**PCN: V15-002-476103-0A**

**Product Change Notice**

To standardize the two channel codewheels assembly on 6mm and 1/4 inch hub ID with mounting boss

Hub ID	Top View	Side View
1/4 inch		
6 mm

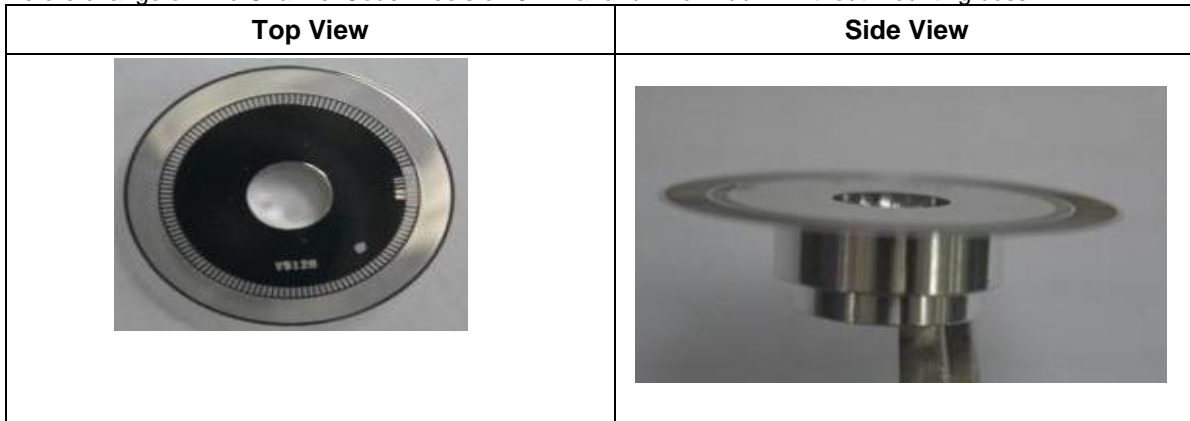
Before change of Two Channel Codewheels on 6mm and 1/4 inch hub ID without mounting boss

After change of Two Channel Codewheels on 6mm and 1/4 inch hub ID with mounting boss

To standardize the two channel codewheels assembly on 6mm and 1/4 inch hub ID with mounting boss. This is to prevent potential misalignment of the codewheel onto on 6mm and 1/4 inch hub ID without mounting boss.
